PG&E TOPOCK GROUNDWATER REMEDIATION PROJECT

Work Variance Request #7 – Proposed changes to Construction Headquarters (CHQ) and Soil Processing Yard (SPY)

Variance Request No.: 7

PROPOSED CHANGES TO CHQ - WORK VARIANCE REQUEST #7

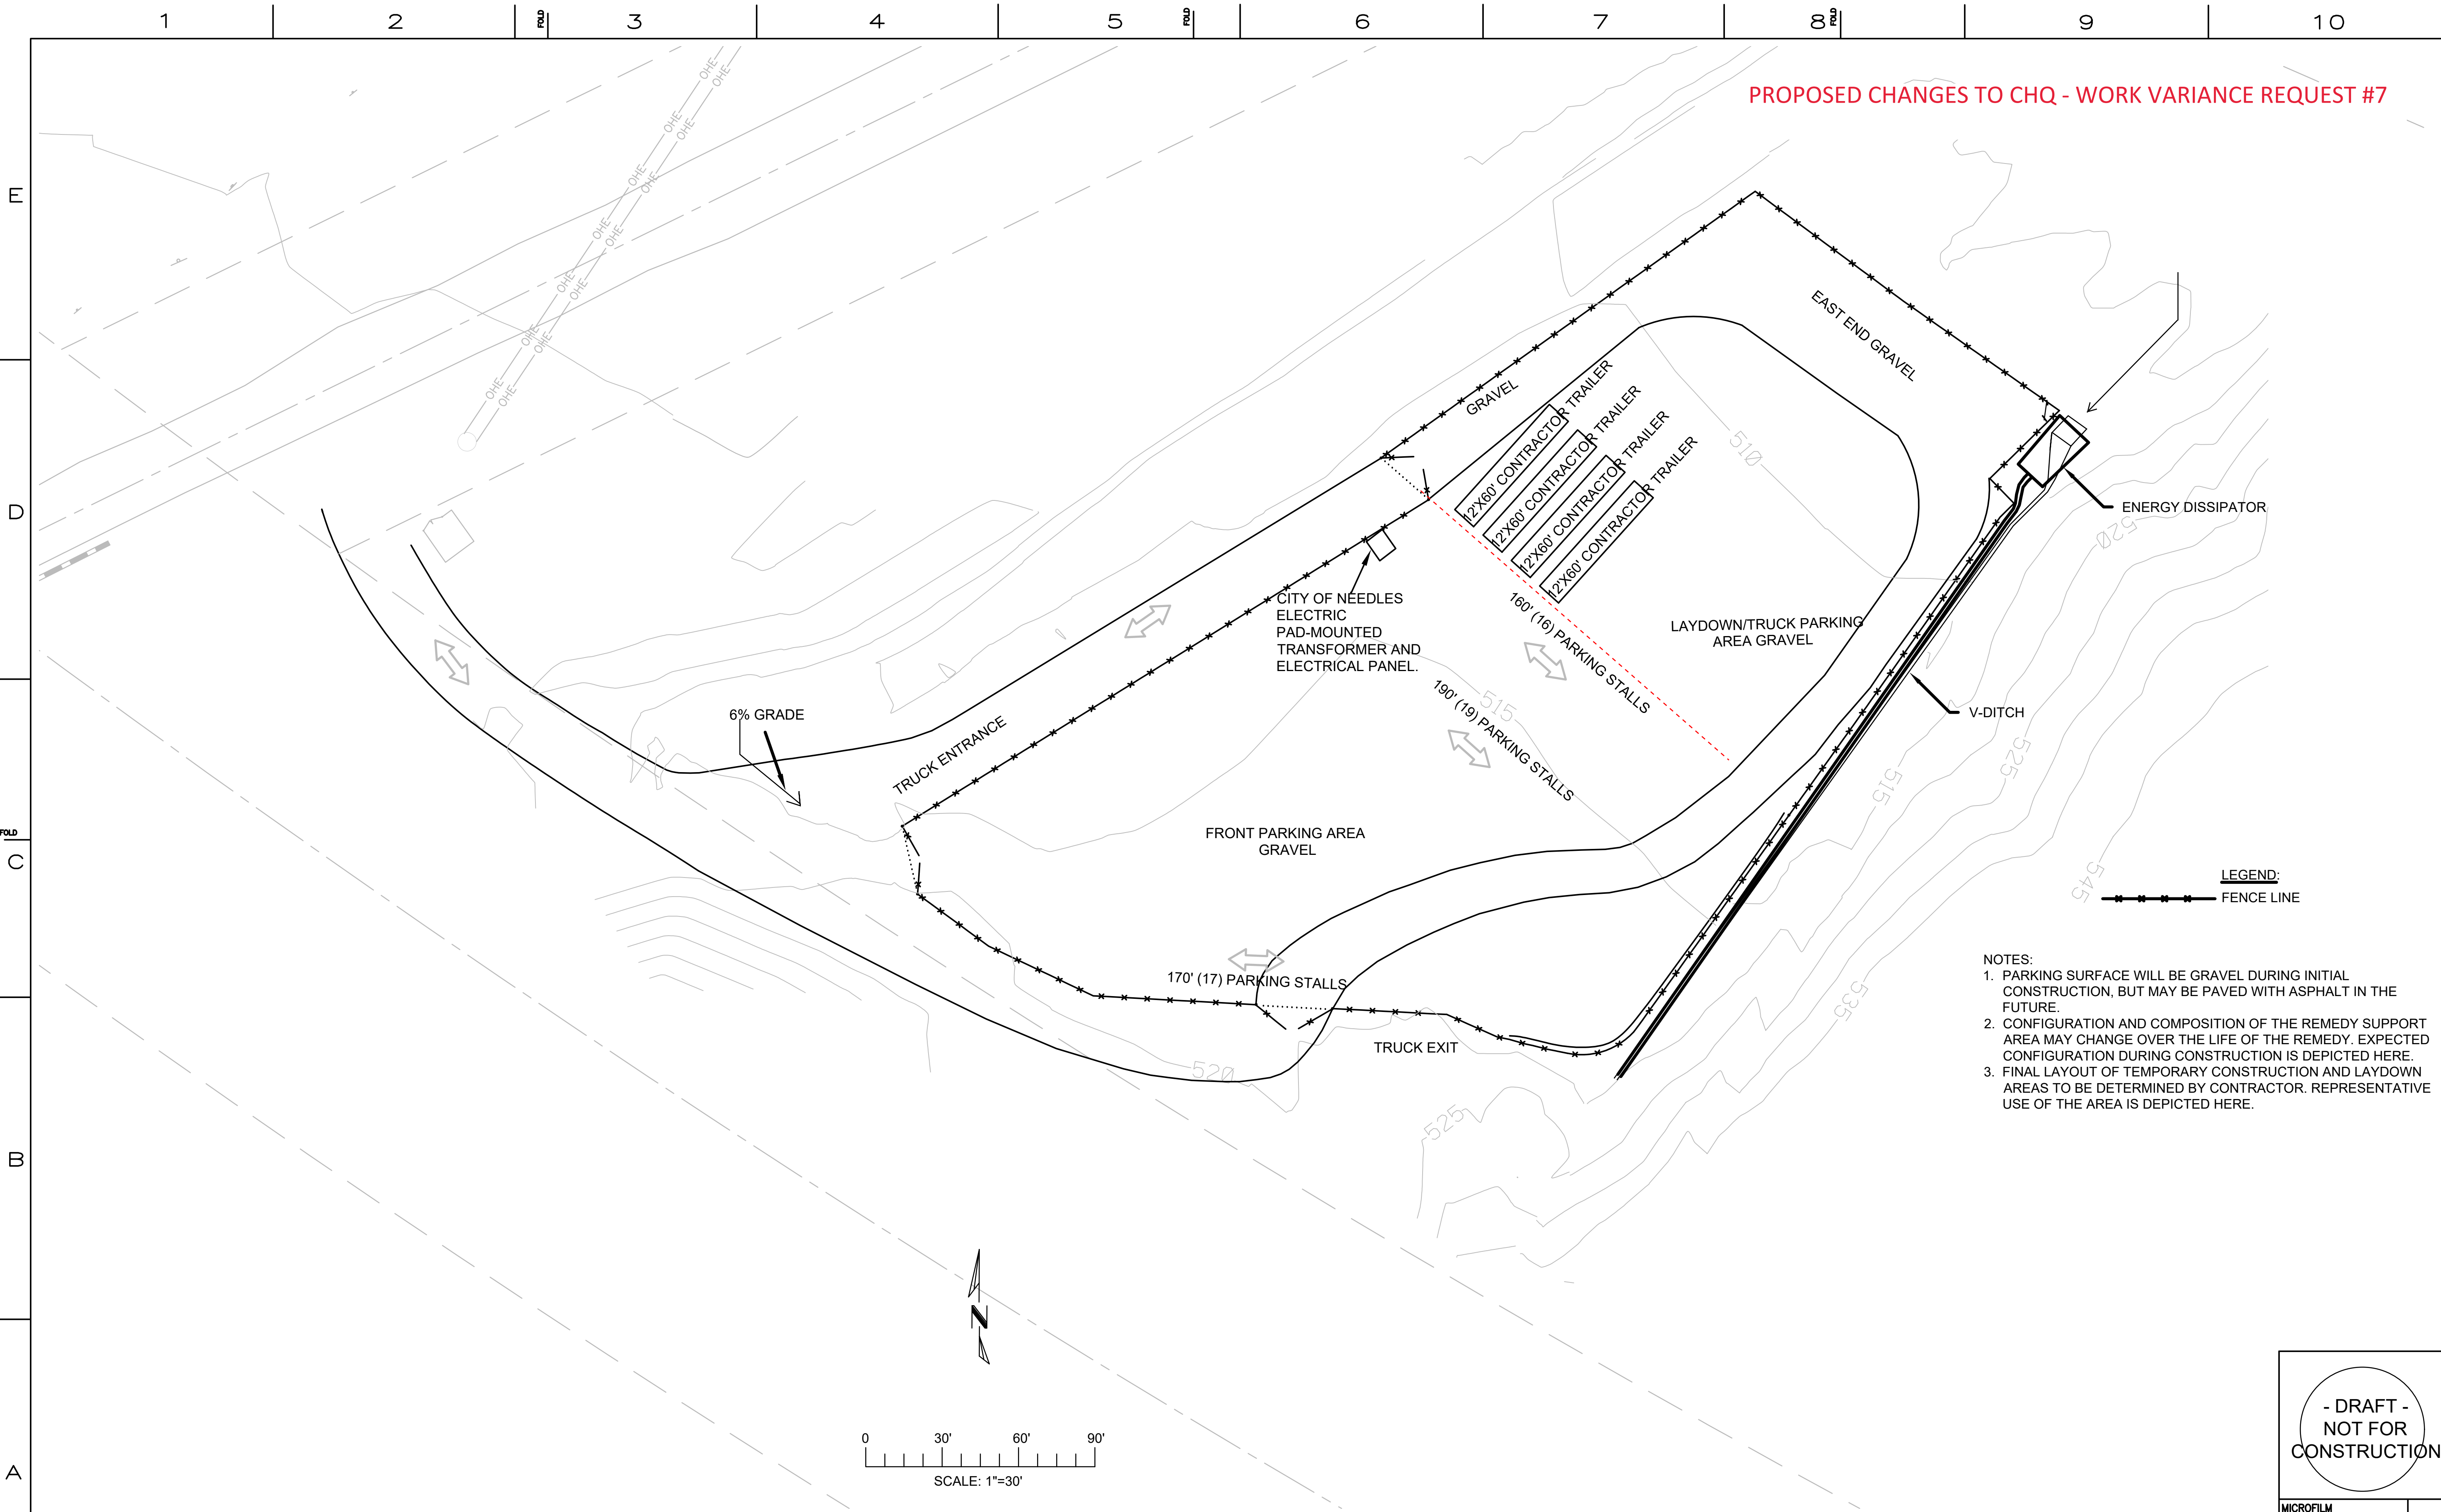
- b) **Eliminate the workshop/sample processing building at the CHQ.** The function planned for this building will be moved to the Carbon Amendment building at the MW-20 Bench. Removal of this building reduces the amount of soil disturbance by approximately 334 cubic yards.

- c) **Eliminate the sunshade at the CHQ.** The function for the sunshade will be replaced by the break trailer for the workers. Removal of the sunshade reduces the amount of soil disturbance (i.e., installation of the footings) by approximately 14 cubic yards.

- d) **Convert the utility pad at the CHQ to a smaller transformer/electrical panel pad.** With the relocation of the six trailers to SPY and elimination of the workshop/sample processing building, PG&E proposes to convert the utility pad to smaller pad for a smaller transformer/electrical panel to serve the few remaining construction trailers at the CHQ. This reduces the amount of soil disturbance by approximately 61 cubic yards.

- e) Defer construction of the equipment decontamination pad and the aboveground remedy produced water tank at the CHQ until the end of Phase 2. Use the CHQ primarily for temporary equipment/vehicle parking and temporary equipment/materials staging. The current practice to decontaminate drill rigs/equipment at the drilling location and/or at the Transwestern Bench eliminates the need for the decon pad and the tank to contain decon water at the CHQ during construction. However, after Phase 2 construction is complete, PG&E anticipates that a decontamination pad and a tank to contain decon water will be needed during the operation and maintenance phase.

PROPOSED CHANGES TO SPY - WORK VARIANCE REQUEST #7

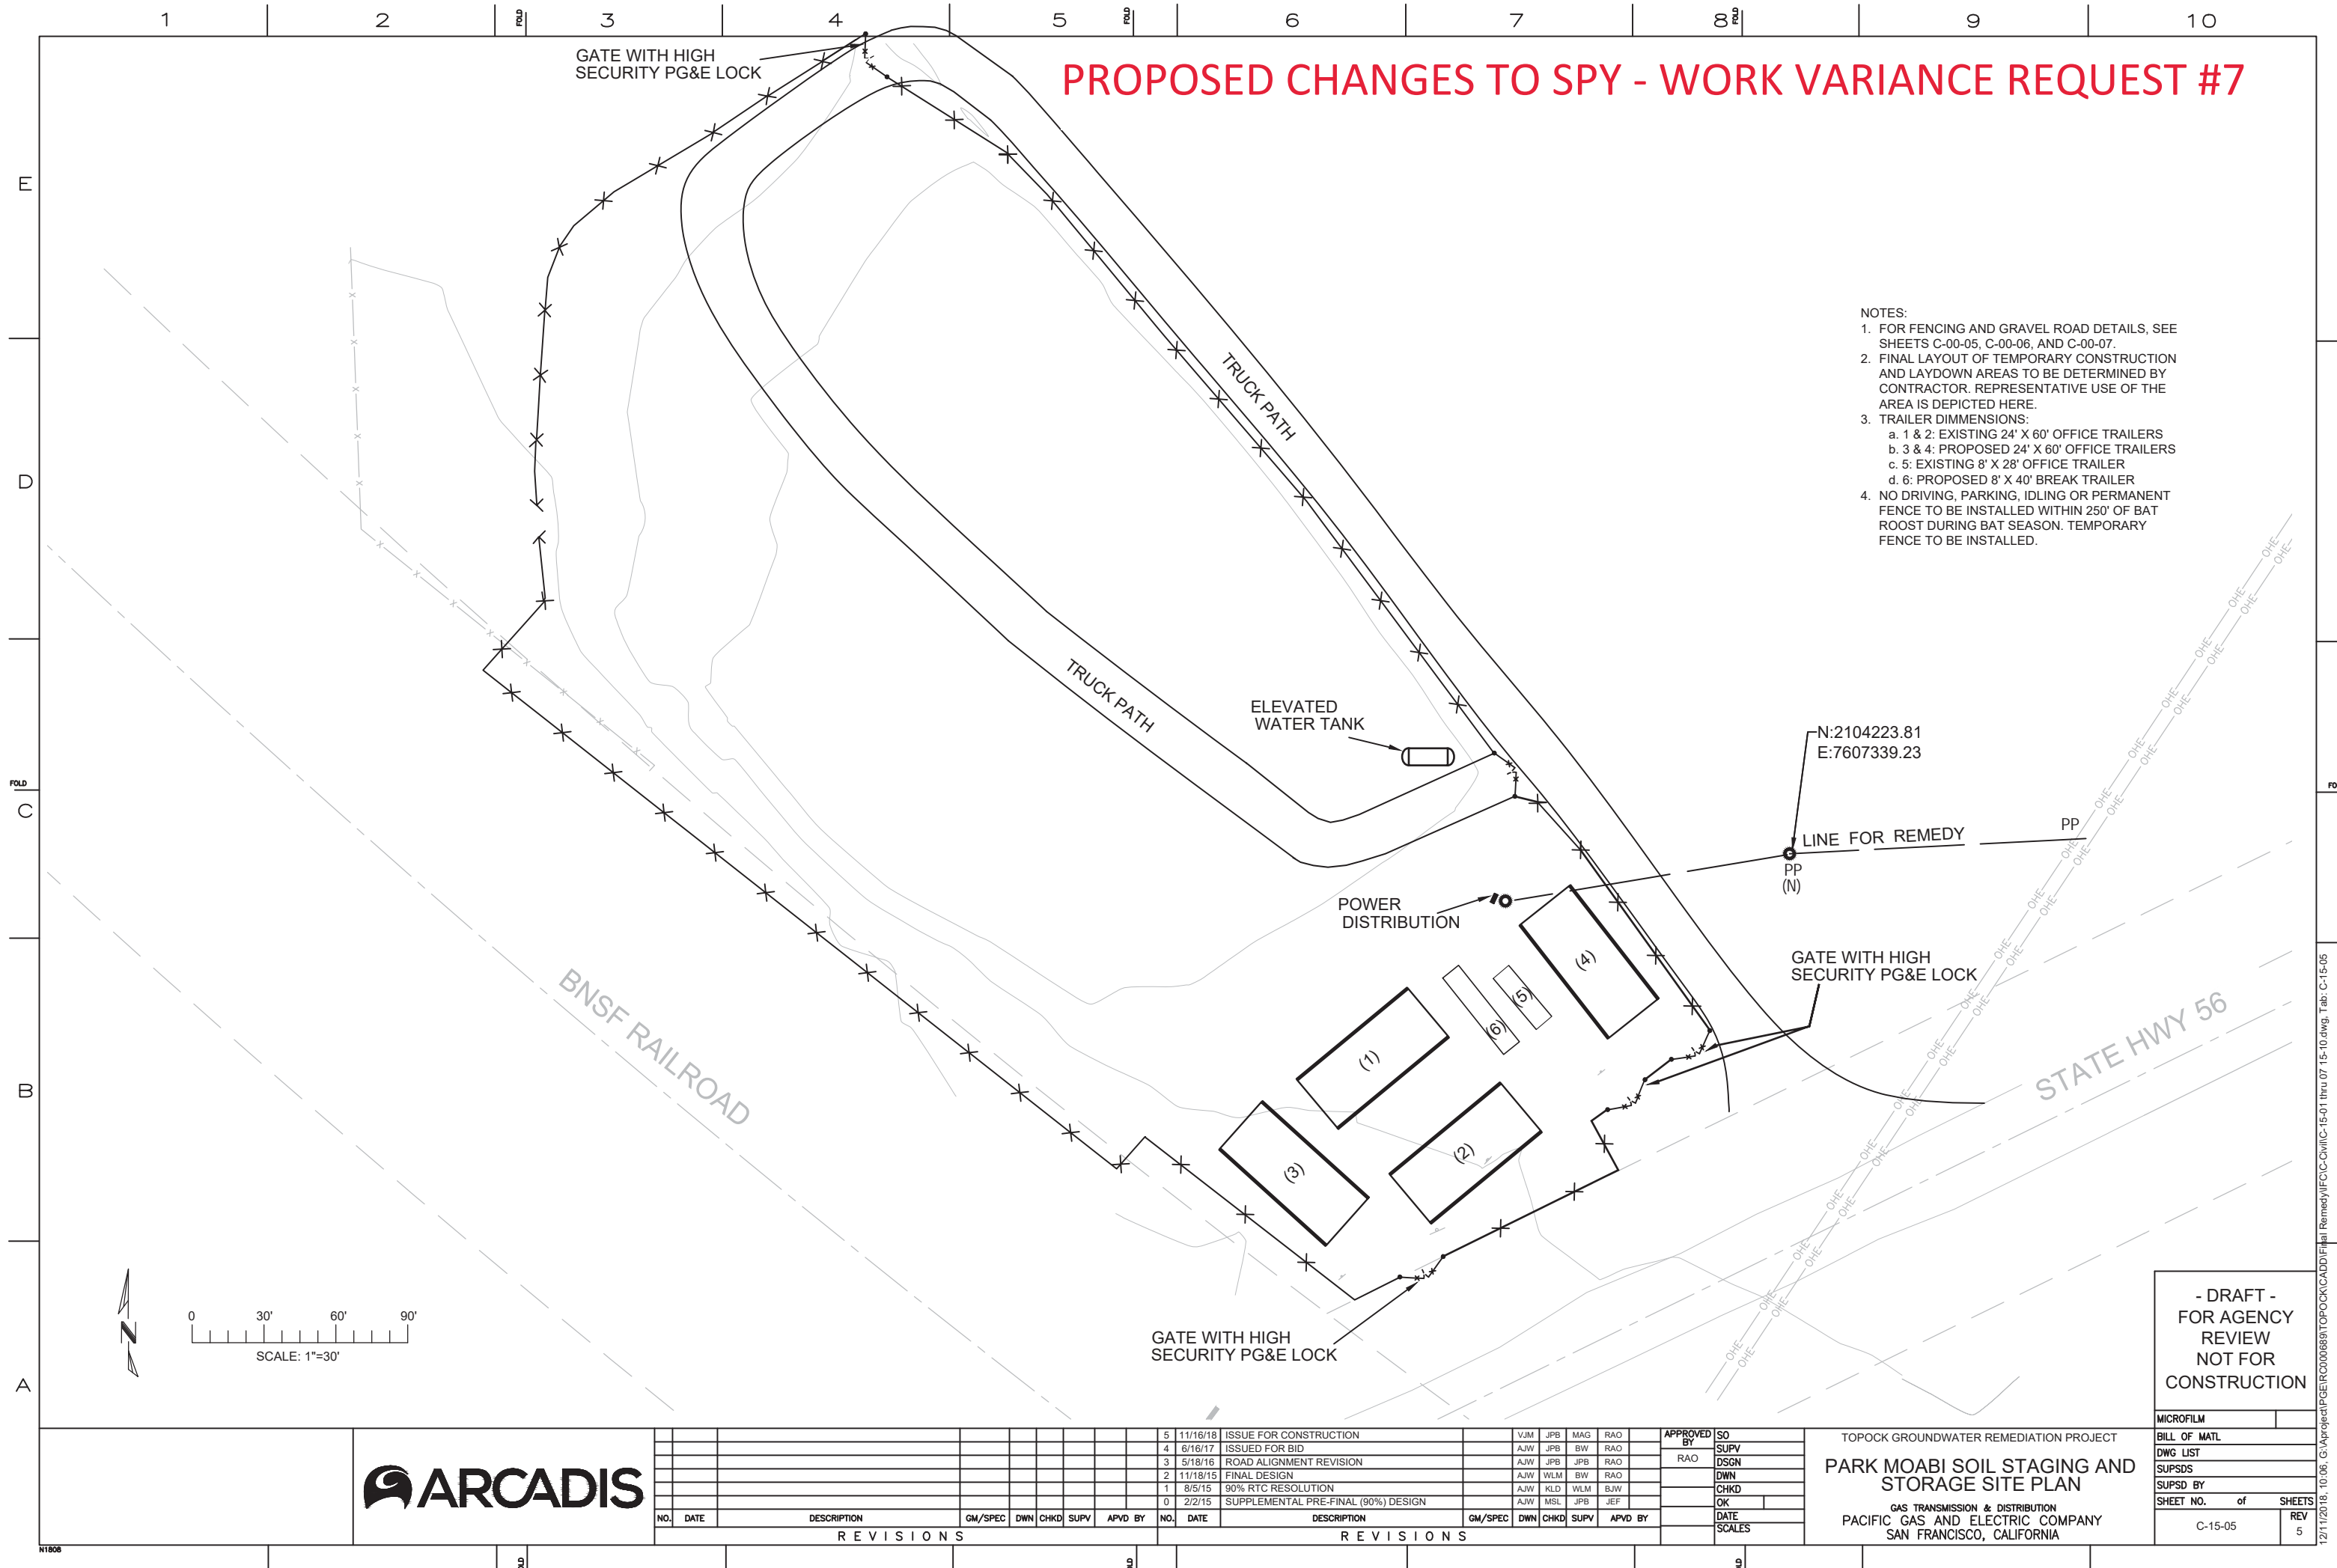
- a) **Locate all temporary office and break trailers at the SPY.** PG&E proposes to keep the three existing office trailers at their current locations in the SPY and add two additional office trailers and one break trailer for workers. The additional trailers will be equipped with aboveground sewage tanks, similar to the existing trailers. They will also be powered by Needles Electric.
This will require the original SPY fence line to be extended south/southwest to encompass these trailers and the original truck entrance from National Trails Highway to the access road east of SPY. Neither changes reduce the overall area available for soil storage.
